# **Audubon Arkansas Comments**

**on Entergy's 2012 IRP**

Prepared by  
**Paul Chernick**

September 26, 2012

**Figure 1: Entergy and Henry Hub Natural Gas Forecasts and Futures**

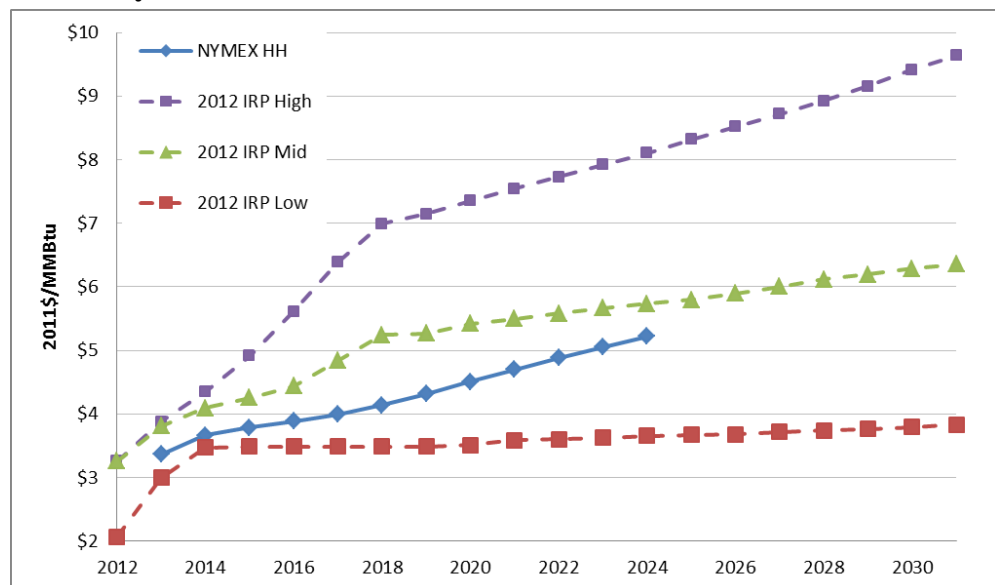
Natural-gas prices affect many important resource decisions, including whether to refurbish Entergy Arkansas’s existing gas steam units and whether to spend hundreds of millions of dollars to keep the White Bluff and Independence coal plants in operation. The mid-range Henry Hub gas prices used in Entergy’s IRP are considerably higher than current futures prices; see Figure 1.<sup>1</sup> Through 2019, the futures prices are closer to Entergy’s low prices than its mid-range prices.

Both the NYMEX market participants and Entergy’s forecasting staff attempt to capture much the same set of considerations (resource potential, changing technology, environmental regulations, demand from consumers, power generation, and exports). However, it is important to recall that the NYMEX prices are real prices, produced by the combined projections of a large number of partici-

pants, rather than the opinions of a small group of Entergy employees. Market participants lay out actual money on the accuracy of their expectations, with strong incentives not to overpay or undercharge, while Entergy's forecasters are paid to produce text and tables, not financial results.

If market participants, or anyone else with funds to invest, believed that the Entergy gas-price forecast was really more dependable than the NYMEX futures, they would make their decisions based on that forecast. In the current situation, those smart gas users and speculators would lock in all the gas they might conceivably want through the futures market, while the smart sellers would refuse to sell at those prices. The speculators would experience large gains, the net buyers would save large amounts of money, and sellers would increase their revenues. Market participants would flock to follow the advice of those prescient forecasters.<sup>2</sup>

With all that buying and little selling, futures prices would rise toward the forecast prices, eliminating the price differentials and the opportunity for windfalls. It does not appear that most market participants have been convinced that Entergy's forecasts provide any significant information about the direction of future gas prices.

The futures market is particularly valuable for updating price forecasts in periods of rapid change in underlying factors. Futures for the out years (2015 and beyond) fell steadily from early 2011 through April 2012, and have traded in a narrow range since. The Entergy forecast may have been developed prior to April 2012, in which case the Entergy forecasters would not have all the information available to the market.

**Figure 2: Natural Gas Forecasts, Docket 09-024-U and Today**

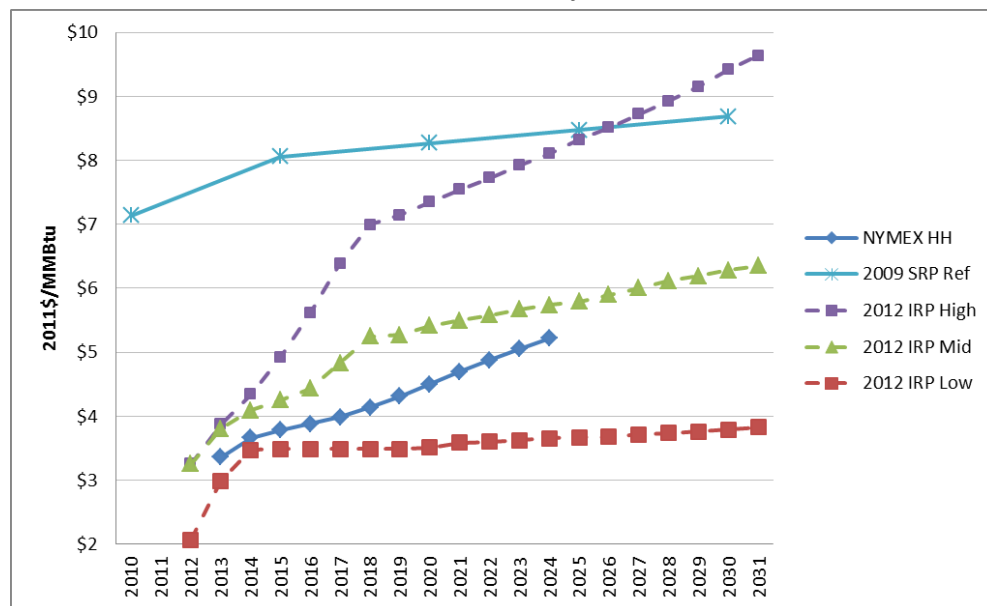
In terms of natural-gas prices, Entergy's analysis in Docket No. 09-024-U used price forecasts contemporaneous with Entergy's 2009 System Resource Plan. Figure 2 compares the reference gas prices from the 2009 SRP to the gas prices that Entergy (2012a, 10) projected in the 2012 IRP presentation. The 2009 reference-price forecast was greater than the current high forecast through 2025

and was more than \$2.50/MMBtu greater than the current mid-range gas forecast through the forecast period.

Revising the 2009 gas prices to current expectations would almost certainly eliminate any economic benefit from continued operation of the coal plants, even with optimistic assumptions about required environmental retrofits.
